Redesign for ISKAMATIK B protection device/switchgear control

AS11

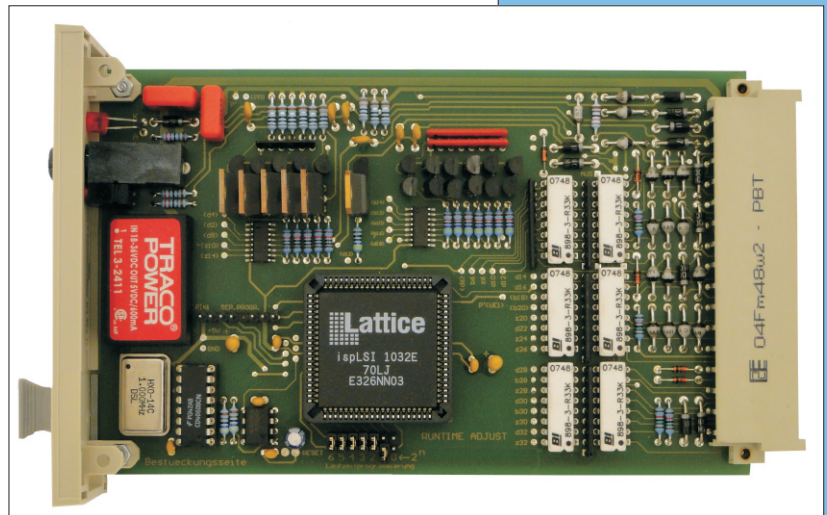
The module AS11 of the control system ISKAMATIK B can be replaced, pin and function compatible, by a redesign.

All special functions of the logic components S132, S133, S134, S135, and S137, which are not commercially available any more, have been implemented in a CPLD, so the original unavailable modules can be replaced "plug and play" by the redesign modules.

The output circuitry (S237, S238, S240) has been descret-designed with especially solid components.

All control and signalling functions of the system remain totally unchanged, as well as the command section, the binary signal processing part, the signalling system and the monitoring system.

In the monitoring system the watchdog timer can be set precisely by the user by encoded switching jumpers. Preset 10S.
